URBAN DESIGN COMMITTEE

URBAN DESIGN COMMITTEE STAFF REPORT

APPLICATION NUMBER	Urban Design Record #23126
APPLICATION TYPE	Advisory Review
ADDRESS/LOCATION	205 S 10 Street
HEARING DATE	November 07, 2023
ADDITIONAL MEETINGS	-
APPLICANT	Joy Skidmore, joy@theannexgrp.com
STAFF CONTACT	Arvind Gopalakrishnan, 402-441-6361, agopalakrishnan@lincoln.ne.gov

APPLICATION NUMBER	Urban Design Record #23119
APPLICATION TYPE	Advisory Review
ADDRESS/LOCATION	1040 O Street
HEARING DATE	August 01, 2023
ADDITIONAL MEETINGS	-
APPLICANT	Daniel and Tamara Sloan, tamara@millcoffee.com
STAFF CONTACT	Arvind Gopalakrishnan, 402-441-6361, agopalakrishnan@lincoln.ne.gov

Material Palette

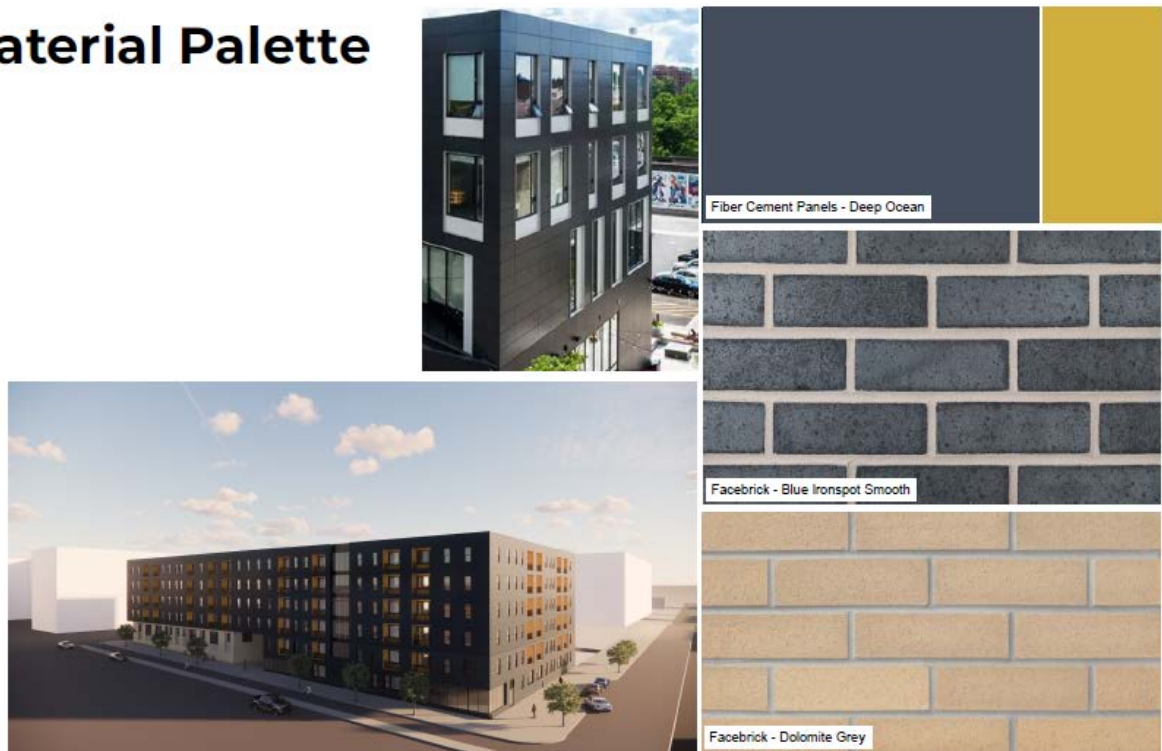
The proposal displays the use of facebricks up to the third story from the sidewalk, fiber cement panels from the third story up to the top of the building.

- Use of lap or shingle siding of any material including wood, vinyl, cementitious, or painted or corrugated metal is prohibited for Downtown Lincoln buildings. - *Compliant*

City staff supports the material choice and the color palette, and suggests that the North elevation fronting N Street have a pop of color or other feature (i.e. yellow fiber cement panel in the floors above the main entrance shown below). This would not only help emphasize the entrance to the building, but also create a

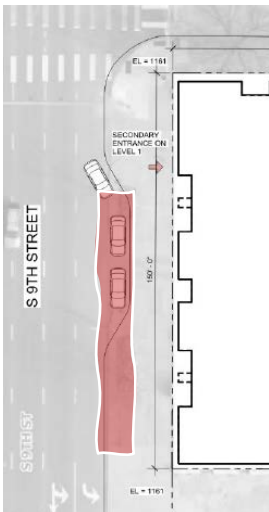
In the updated drawings, the proposal shows a preliminary vehicular drop-off area near the secondary entrance on level 1, on 9th Street. Staff recommends that the proposed area drop off area on 9th Street be extended southwards to the extent of the building and provide more space for loading and unloading. This detail will need to be addressed at a later date, along with streetscape design concepts.

Streetscape Design:

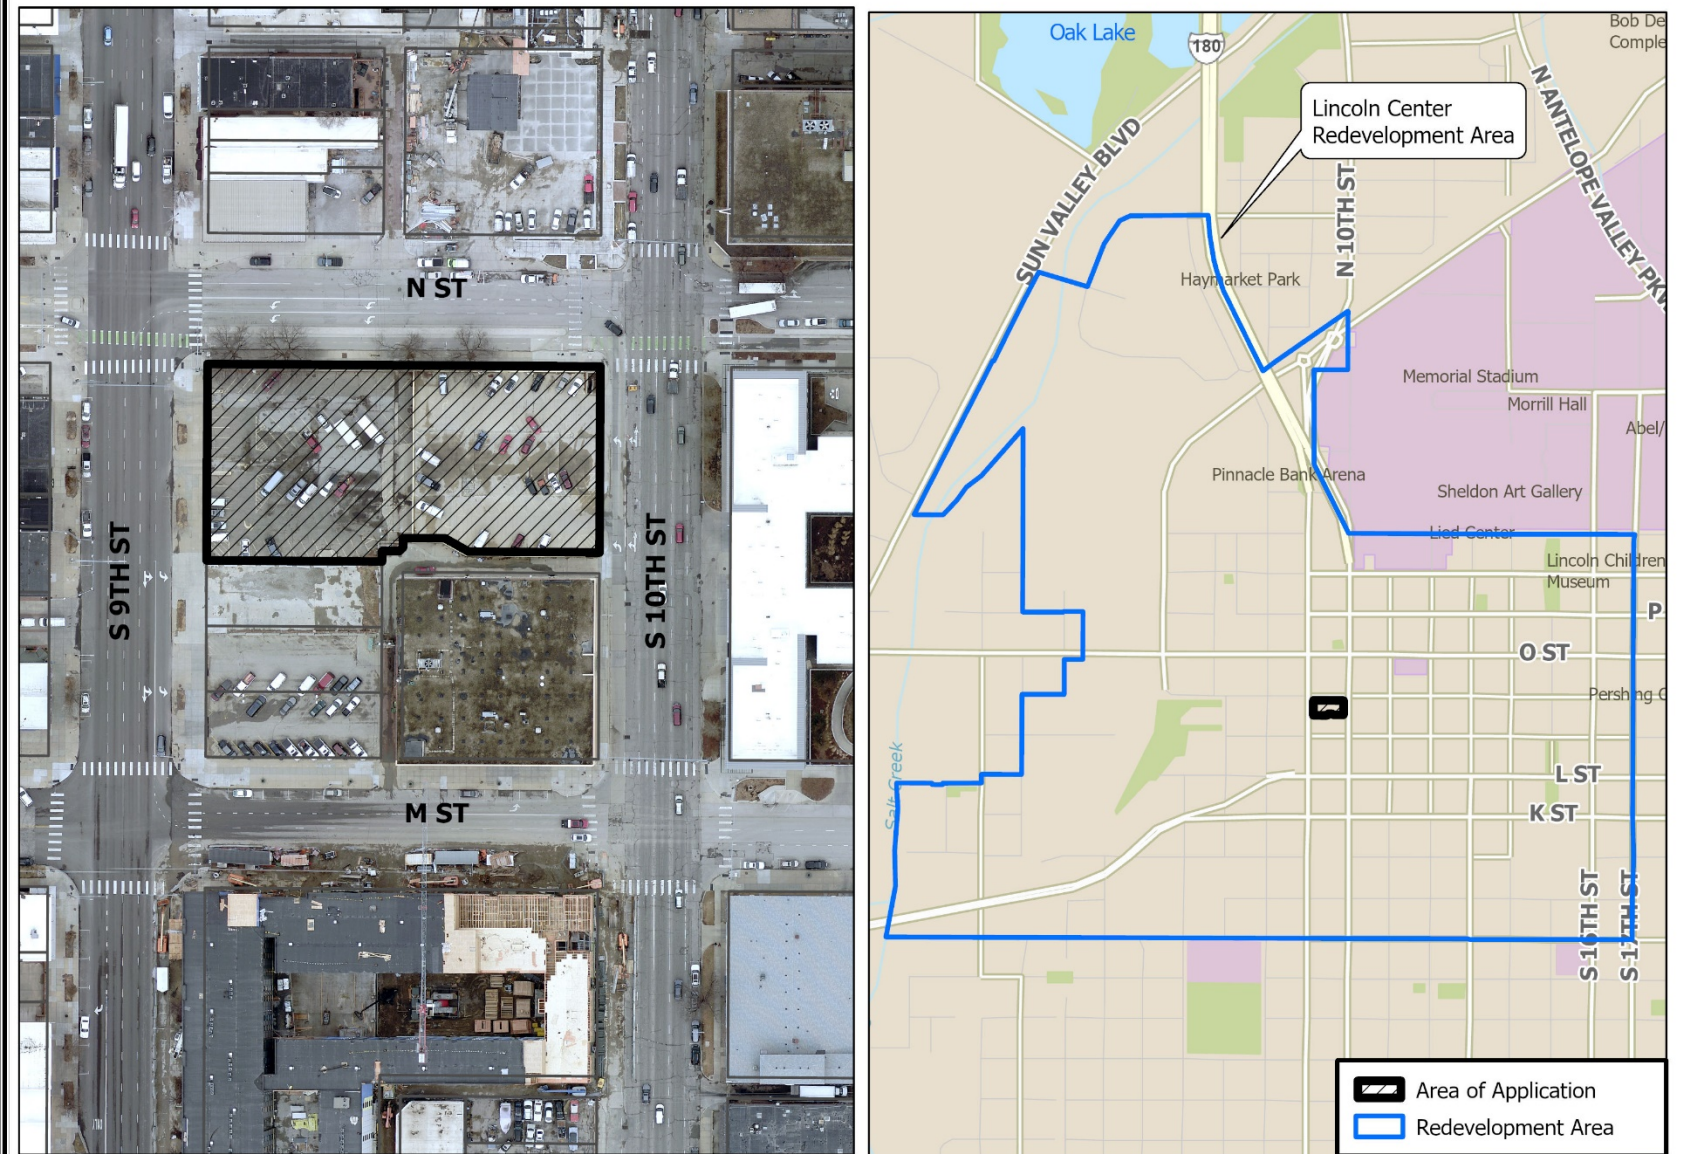
Landscaping and other streetscape design concepts will be presented at a later date, likely in early 2024. This will be a coordinated effort between the applicants and the concerned departments of the City to ensure that the proposed design aligns seamlessly with the City’s overarching goals for 9th and 10th Streets as part of the Downtown Corridors Project, emphasizing safe and efficient traffic movement for pedestrians, cyclists and vehicles, while creating a visually appealing urban environment.

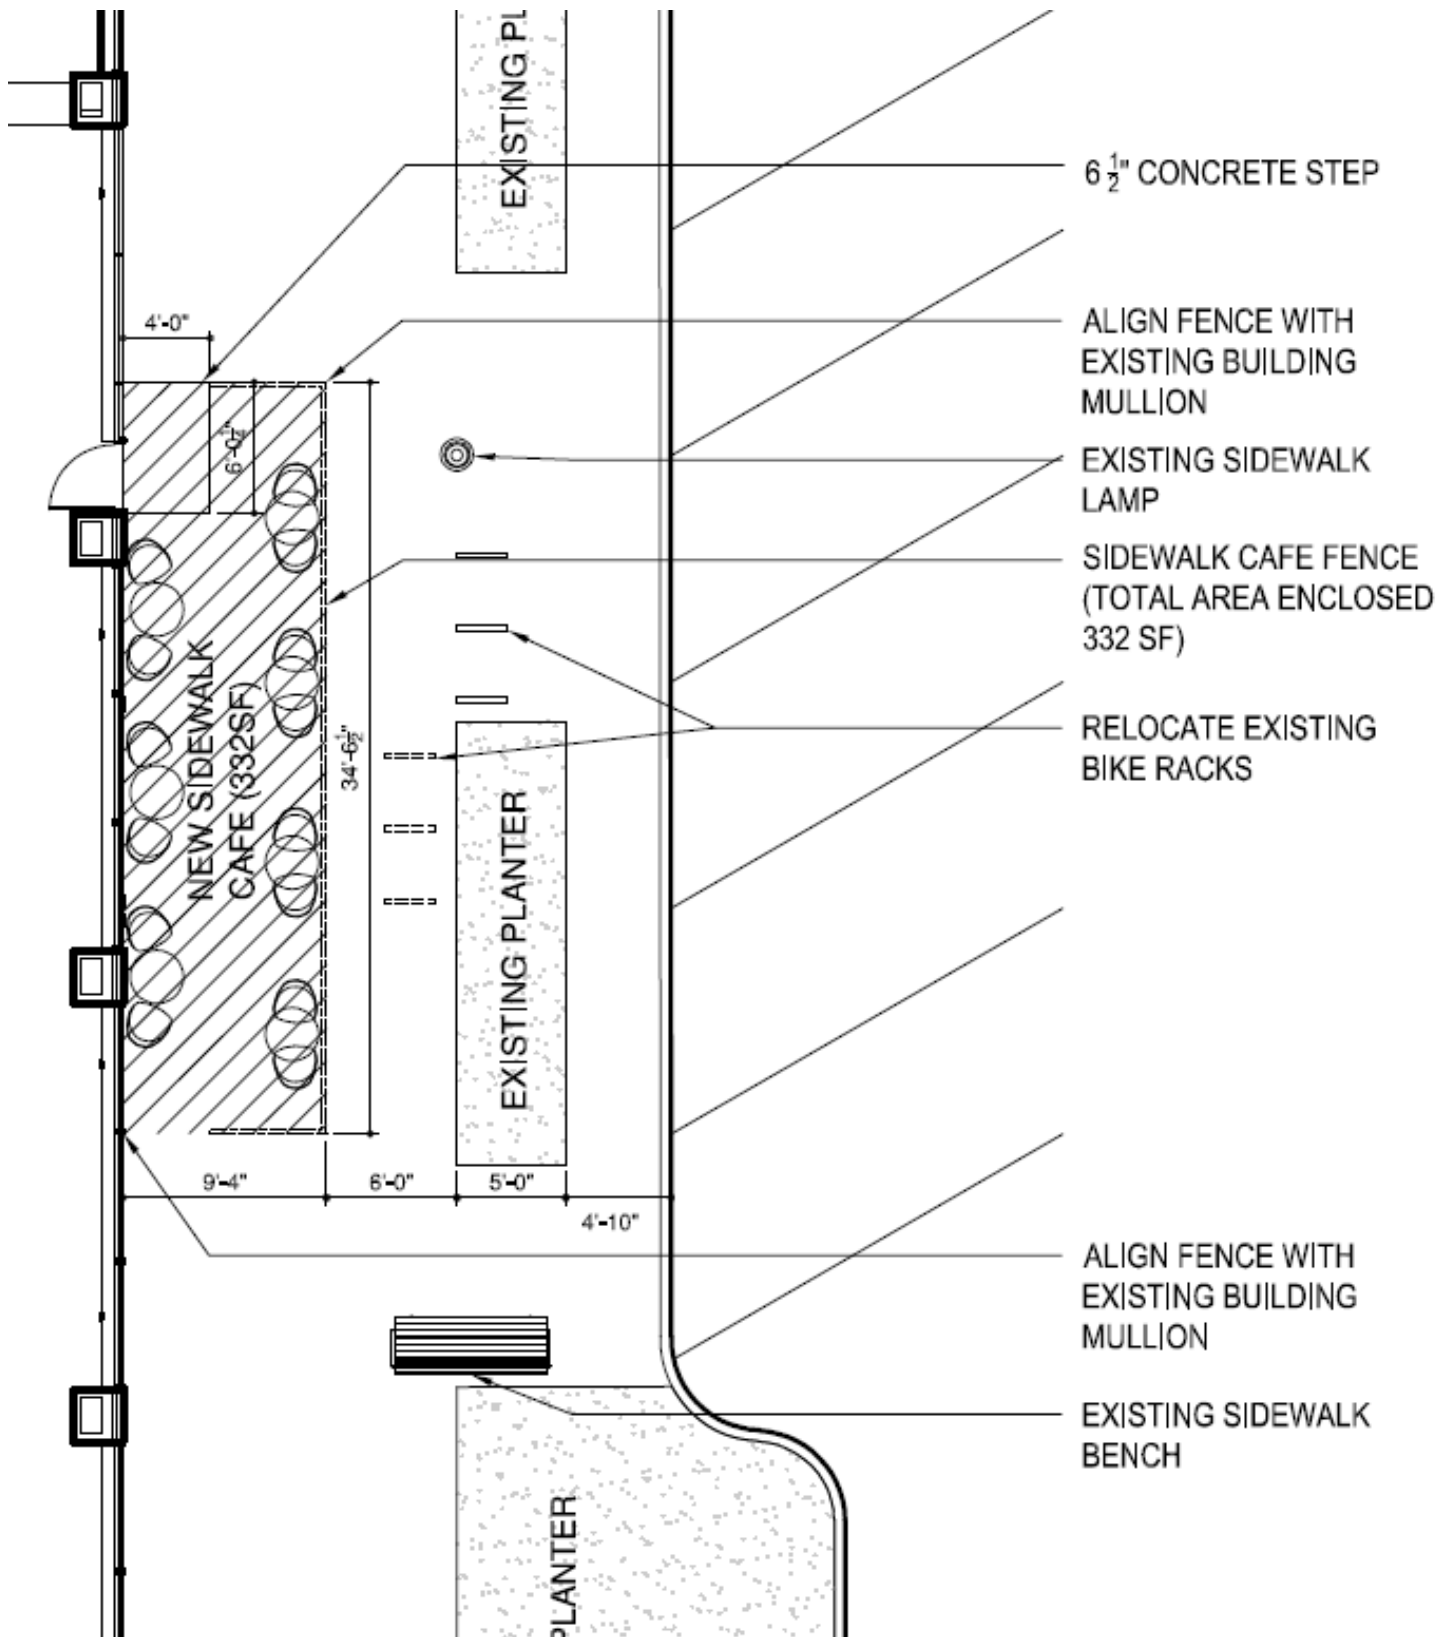
The fencing has been installed as per the drawings, and the bike racks have been uninstalled to make space for pedestrians. After the removal of the bike racks, the current sidewalk café width of 9’-4” would leave 6’ for pedestrian movement. The city will coordinate with the DLA to install the bike racks slightly east, aligned with the existing planter.

City staff also recommends that the metal bench just south of the café and the set of 2 benches north of the café (circled in the map above), be removed from its current position, and relocated about 3' to the east, aligned with the existing planters. This would help ensure a smooth flow of visitors to and from the sidewalk café and leave enough space for bike parking without interrupting the pedestrian flow on the sidewalk.

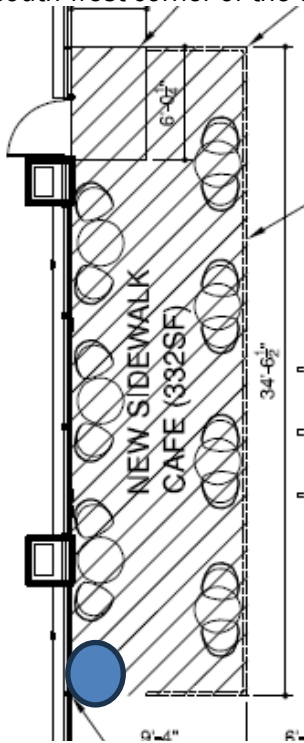
The DLA has removed the 3 bikeracks and will be in touch with the city for relocation, to make sure that it doesn't encroach on the pedestrian passageway.

The city will also coordinate with the DLA to remove metal bench south of the café, and find an appropriate spot for relocation. Since this part of 11th Street falls in the Downtown Corridors Project

ATTACHMENT B – Site Plan

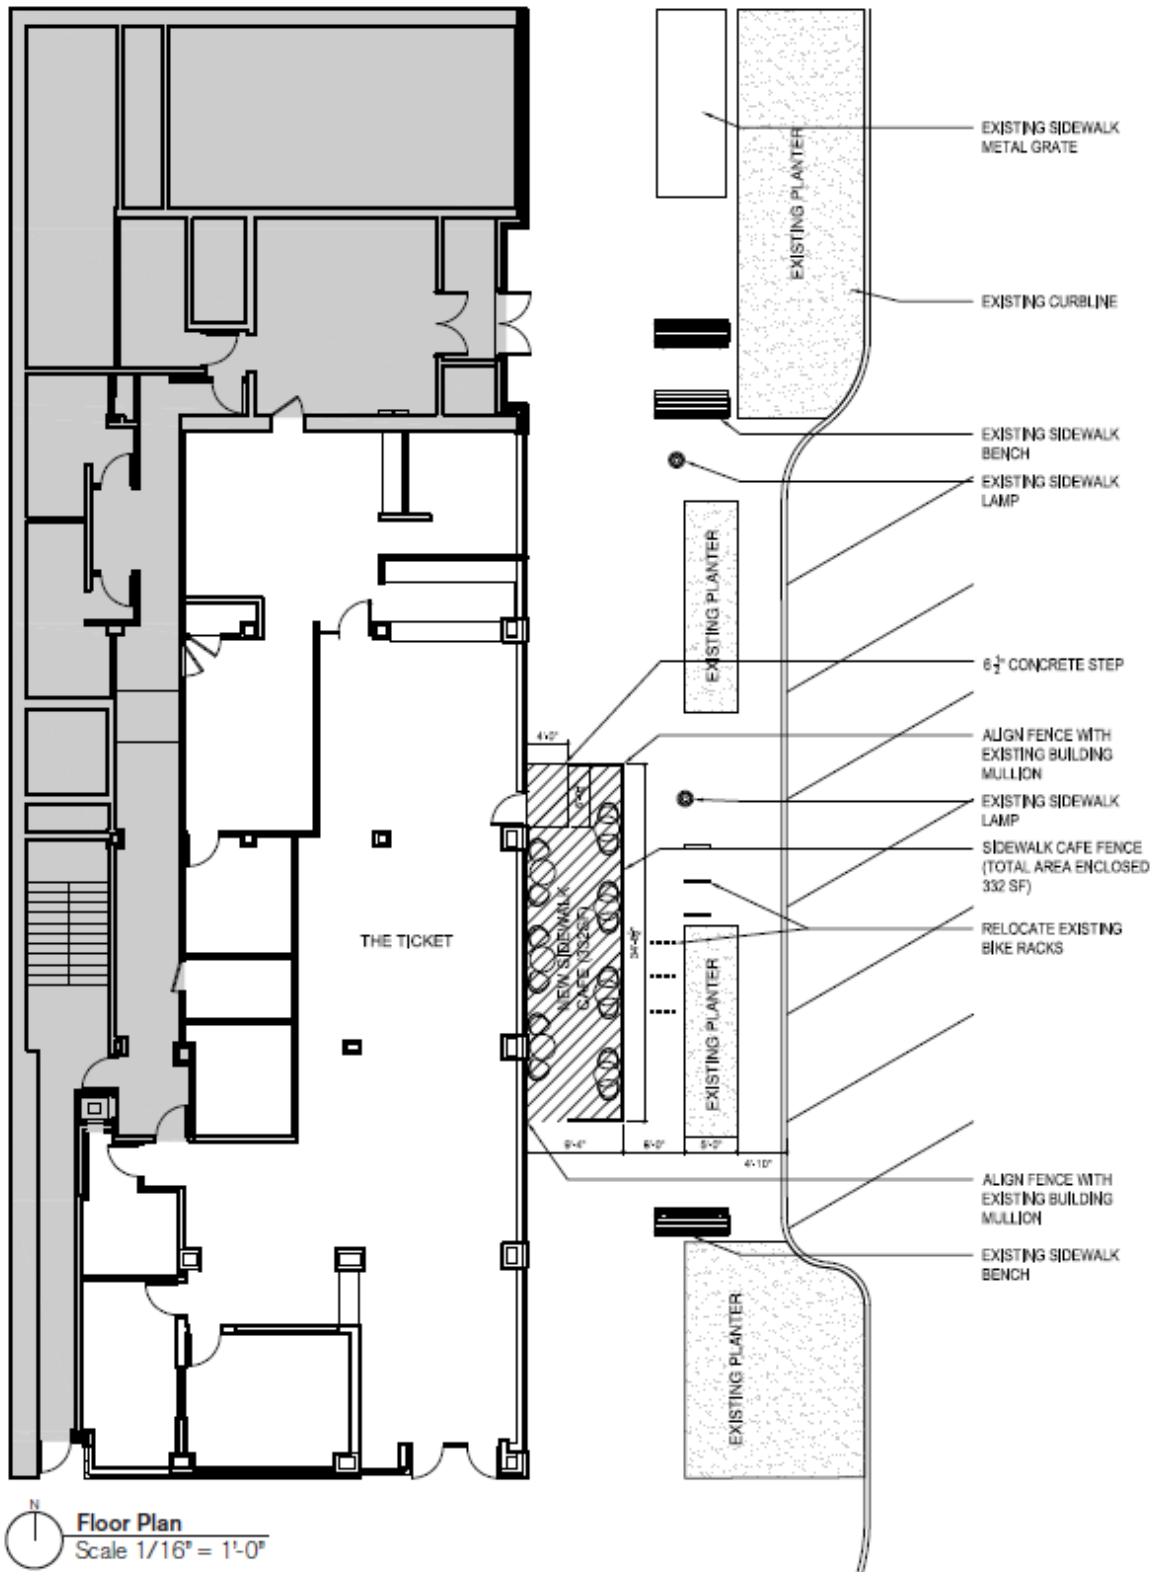
The application shows 7 sets of 22 inch two-seater round tables, of which 4 sets are placed along the railing side, and 3 sets placed against the exterior wall of the building. However, the applicant has confirmed that they would be ordering 22 inch square tables. (image below)

The position of the trash receptacle is not included in the site plan, but the applicant has confirmed that it would be included in the café.

- City staff approves of the 22 inch two-seater square tables, and three trash receptacle.
- Since the trash receptacle is not included in the site plan, we recommend that it be placed in the south-west corner of the café.
